General Aviation Division
Rockwell International

SERVICE INFORMATION NO. SI-102

EFFECTIVITY: MODEL 112, SERIAL NO'S 3 THRU 226.

SUBJECT: FAA AIRWORTHINESS DIRECTIVE 74-24-13.

Figure 3. Regulator Valve Stem Location Model RSA-5/RSA-10

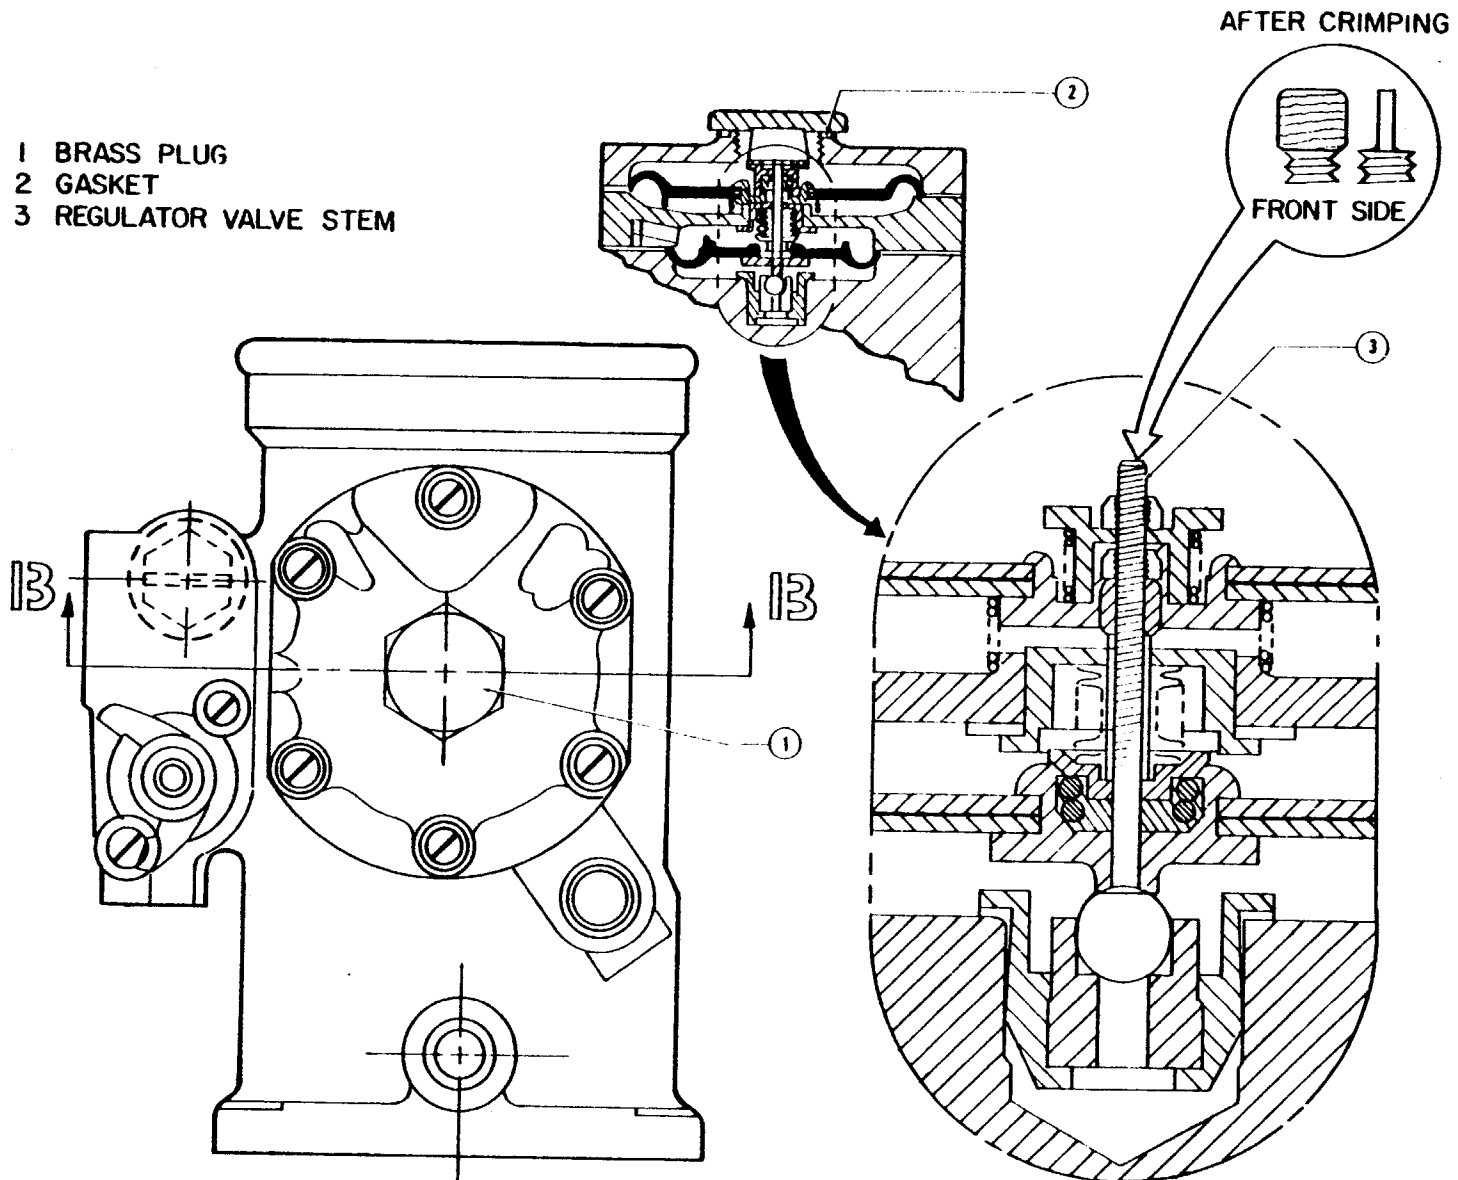
- a. If the injector is accessible, perform Steps 1 through 6 below;
 - b. If the injector is not accessible, remove the injector to a well lighted work bench and perform Steps 1 through 7 below;
 - c. The Model RSA-5AB1 with Automatic Mixture Control (AMC) attached must be removed from the engine. Disassemble the AMC from the injector using the following sequence:
 - (1) Remove safety wire from the two screws securing the AMC to the regulator body.
 - (2) Loosen and remove the screws.
 - (3) Remove AMC assembly and retain for reassembly.
 - (4) Perform Steps 1 through 7 below;
- Step 1 Locate the brass plug (1 in. hex) on the injector regulator cover, Figure 3 (1).
- Step 2 Remove lockwire and seal from brass plug.
- Step 3 Remove brass plug and gasket, Figure 3 (1), (2).

- b. If one and one-half full threads or more are showing, adjust lock nut clockwise to obtain three full threads. Crimp end of stem, and inspect crimp per Figure 3. Adjust lock nut counter clockwise to its original position.
- c. If three full threads or more are showing, crimp only, and inspect crimp per Figure 3.

Figure 1.

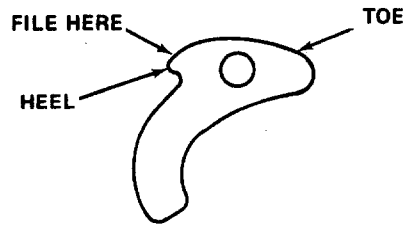
1. REMOVE MAGNETO FROM THE ENGINE IN ACCORDANCE WITH ENGINE/AIRCRAFT MANUFACTURER'S PUBLISHED INSTRUCTIONS.
2. PLACE THE MAGNETO IN A SUITABLE WORK STAND WITH THE IMPULSE COUPLING FACING UP.
3. USE FINGER PRESSURE TO PUSH INWARD ON THE TOE (SEE FIGURE 1) OF EACH FLYWEIGHT SO THAT THE FLYWEIGHT HEEL PROTRUDES OUTWARD.
4. USING A FINE #1, DOUBLE CUT, ½ INCH WIDE FILE AT LEAST 3/32 INCH THICK, PASS THE FILE ACROSS THE HEEL OF THE FLYWEIGHT ATTEMPTING TO REMOVE MATERIAL. (SEE FIGURE 1). IF THE FLYWEIGHT HAS BEEN PROPERLY HEAT TREATED THE FILE WILL "GLIDE" SMOOTHLY OVER THE HEEL OF THE FLYWEIGHT, REMOVING NO MATERIAL. IF THE FLYWEIGHT IS NOT PROPERLY HEAT TREATED (SOFT) THE FILE WILL NOT "GLIDE" EASILY ACROSS THE SURFACE OF THE FLYWEIGHT HEEL, AND MATERIAL WILL BE REMOVED.

5. IF AN IMPROPERLY HEAT TREATED (SOFT) FLYWEIGHT IS FOUND, IMMEDIATELY REMOVE AND REPLACE THE CAM ASSEMBLY AND/OR THE IMPULSE COUPLING ASSEMBLY WITH AN ASSEMBLY MEETING REQUIREMENT OF THIS AD, FOLLOWING PROCEDURES IN THE MAGNETO OVERHAUL INSTRUCTIONS, AND PAYING STRICT ATTENTION TO NOTES AND CAUTIONS.

FIGURE 2. FLYWEIGHT TERMINOLOGY AND POSITIONING

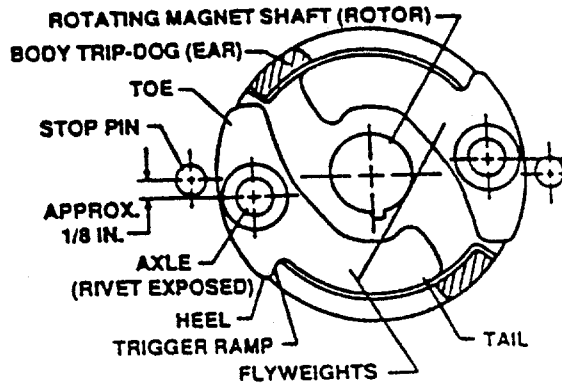
- 1 Impulse Coupling Inspection
 - 1.1 Remove magneto from engine.
 - 1.2 Inspect the heel of the flyweight. See Figure 2. A polished area extending from the heel toward the toe of the flyweight is an indicator of severe wear and the cam assembly must be replaced.

- 1.4 Inspect for flyweight and axle wear on each flyweight as follows:
 - 1.4.1 Rotate the impulse coupling so the flyweight axles are positioned at the stop pins as shown in Figure 2. Lock rotor in place using rotor holding tool. Use of 11-8465 rotor holding tool or equivalent is necessary.

FIGURE 3. WIRE HOOK CONFIGURATIONS
 ALL DIMENSIONS ARE APPROXIMATE

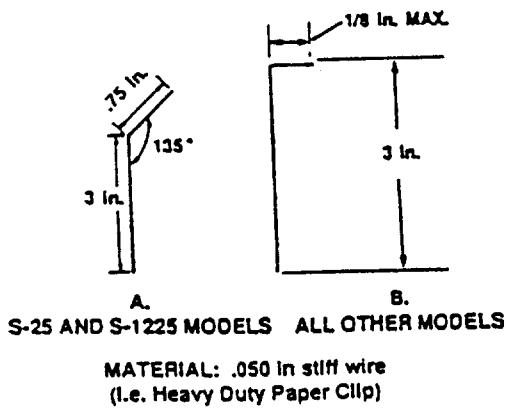
- 1.4.2 For Type S-25 and S-1225 magnetos (with impulse coupling recessed into the magneto flange) push on flyweight trigger ramp (see Figure 4A) using bent wire as shown in Figure 3A. Ensure that flyweight tail rests against body trip-dog. Proceed to step 1.4.4.

- 1.4.3 For all other affected magneto models, form wire into hook as shown in Figure 3B. Reach between the cam and the flyweight with wire hook as near as possible to the stop pin. Pull outward on the flyweight as shown in Figure 4B. Ensure that flyweight tail rests against body trip-dog.

FIGURE 4. "X" VALUE MEASUREMENT

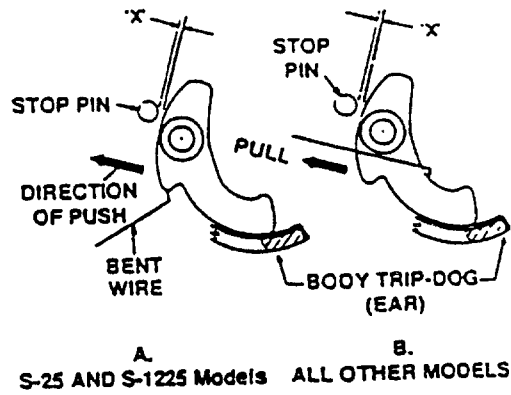
- 1.4.4 Insert feeler gage between the stop pin and flyweight to determine clearance ("X" of Figure 4) while the flyweight is forced outward. Maintain constant outward force on the flyweight while measuring clearance to ensure accuracy.

- 1.4.5 Remove the wire to relax the flyweight. Add .014 in. feeler gauge to your determined "X" value. Attempt to pass "X plus .014" feeler gauges between flyweight and stop pin. See Figure 5. If gauges pass, remove and discard worn cam assembly. Replace the entire impulse coupling assembly or cam assembly with new snap ring impulse coupling or snap ring cam assembly as specified in paragraph 2. If gauges do not pass, coupling may be returned to service or replaced with new snap ring impulse coupling or snap ring cam assembly as specified in Paragraph 2.

FIGURE 6. SNAP-RING CAM ASSEMBLY IDENTIFICATION

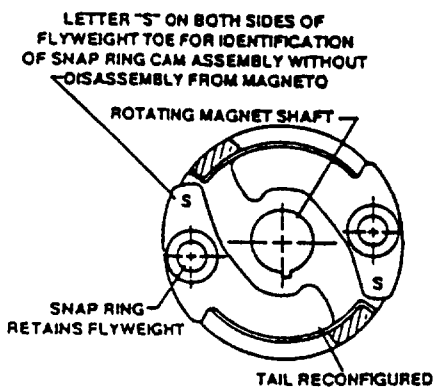
C. As an alternative to recurring 100 hour inspections of RIVETED impulse couplings, operators may at any time either install improved snap-ring impulse coupling cam assemblies (see Detailed Instructions, Paragraph 2) or retrofit to Shower-of-Sparks Ignition where possible. Magnetos retrofitted with snap-ring impulse coupling cam assemblies may be identified as shown in Figure 6. Magnetos retrofitted to Shower-of-Sparks may be identified by part number.

Figure 1.

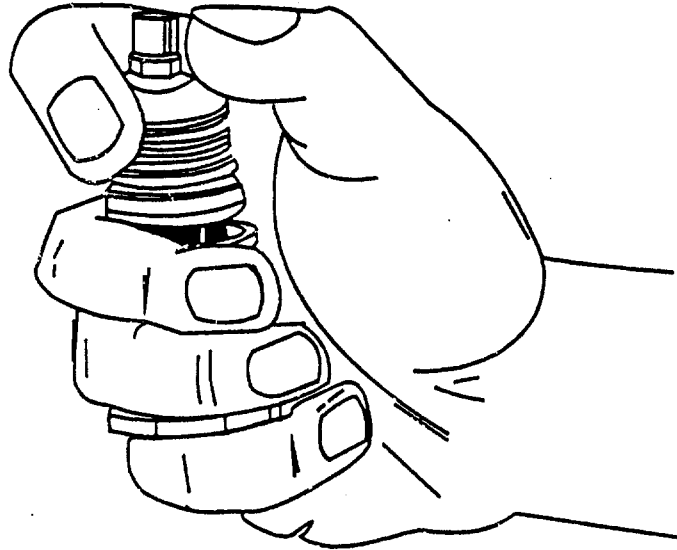
A physical inspection of the crimp nut is required to ensure it is seated and solid on the shaft. Separate the seat and retaining nut by holding the valve assembly in one hand and compressing the valve spring with the forefinger and thumb. (See Figure 1.) With the seat and nut separated, grasp the crimp nut with the other hand and attempt to move it. The crimp nut must not move. If the thermostatic bypass valve assembly does not meet this inspection, it must be replaced immediately.

Figure 1.

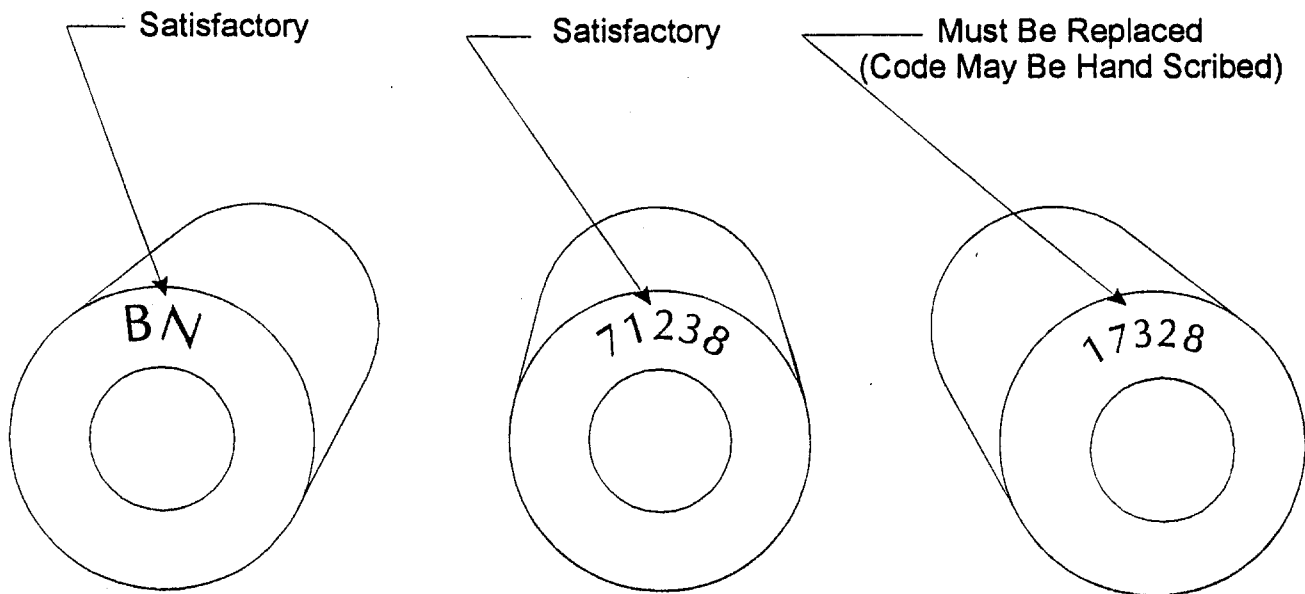
Textron Lycoming has determined that a quantity of piston pins have been manufactured which do not meet Textron Lycoming manufacturing specifications. Some piston pins may have imperfections with no visual method of detection. The subject piston pins are identified by the code number located on the end of the pin as shown in Figure 1.

1. It is mandatory that all piston pins marked with code 17328 (per Figure 1) installed in engines manufactured and shipped from Textron Lycoming be removed from affected engines and returned to Textron Lycoming, Williamsport, PA. Subject engines are listed by models and serial numbers following the text of this bulletin. Satisfactory replacement pins are marked with codes BN or 71238 as shown in Figure 1.

Figure 2.

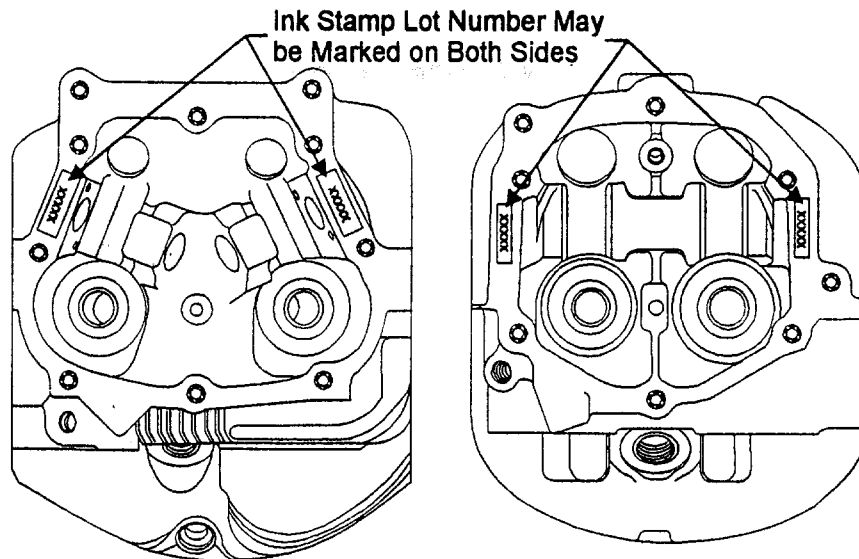
- a. If the cylinder kit has been installed on an engine, the cylinder assembly rocker cover flange must be inspected for a lot number which is permanent ink stamped on the flange (refer to Figure 2). The rocker cover must be removed to examine the lot number. Only the four or five digit number should be used for inspection. Any prefix letters should be ignored. Any five digit lot number and any cylinder marked with a four digit lot number less than 2450 requires the piston pin to be inspected for code marking as per Figure 1. If the four digit lot number is 2450 or greater, no further inspection is required.

Figure 1.

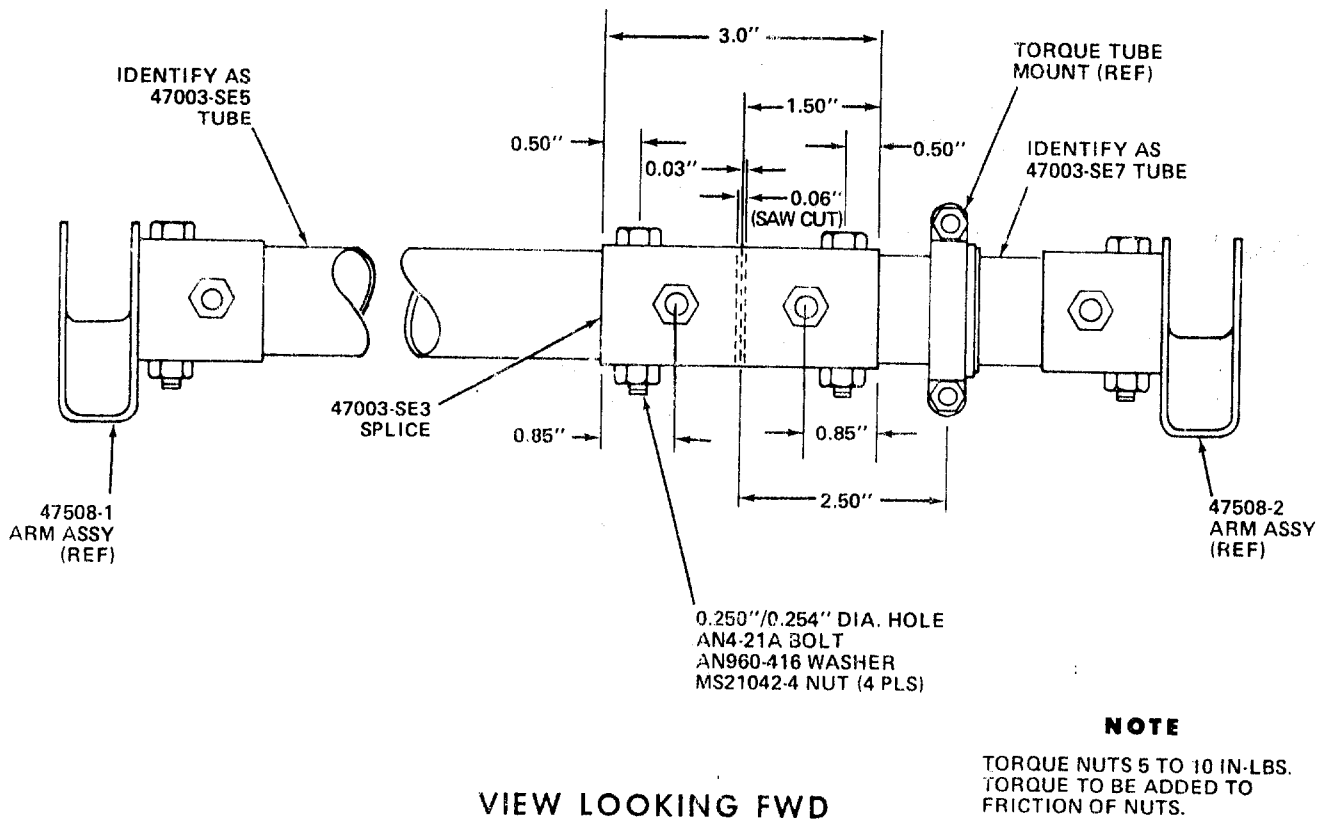
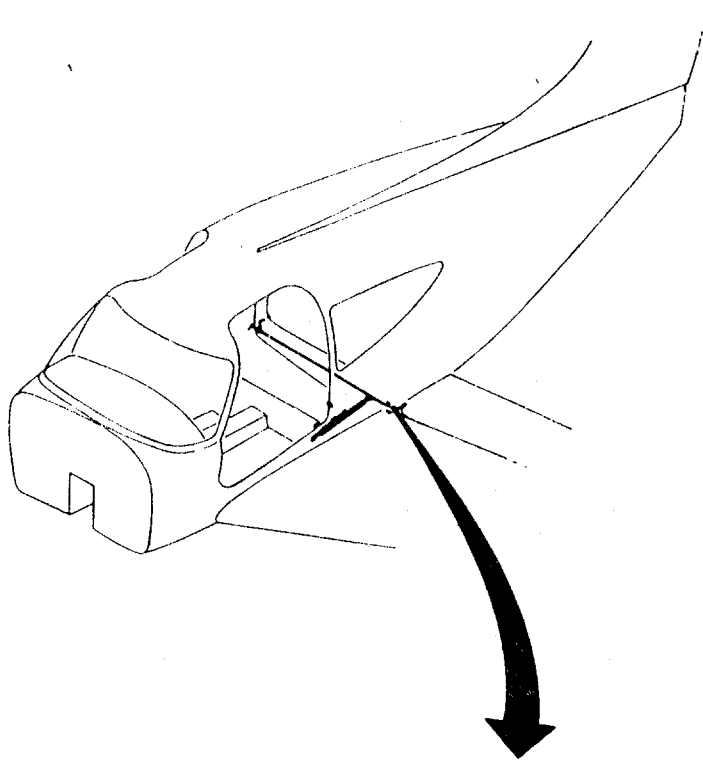
3. Cut existing 47280-1 flap torque tube on right end as shown in Figure 1. and deburr sharp edges. Saw cut not to exceed 0.06-inch width.
4. Position 47003-SE3 splice on flap torque tube, drill and ream 0.250"/0.254" diameter hole (4 places) thru splice and flap torque tube and then remove splice (refer to Figure 1).

The 0.250"/0.254" diameter holes at the outboard ends of the torque tube must be in line with each other as shown in Figure 1.

7. Install 47003-SE3 splice on flap torque tube using AN4-21A bolt (4 places), AN960-416 washer (4 places) and MS21042-4 nut (4 places). Torque nuts 5 to 10 inch-pounds. Torque to be added to friction of nuts (refer to Figure 1).

8. Ink stamp part number 47003-SE5 on left end of torque tube and part number 47003-SE7 on right end of torque tube (refer to Figure 1).
9. Assure that flaps are operating properly.
10. Reinstall floor panels, carpeting and rear seats.
11. Fill out and mail Compliance Card.
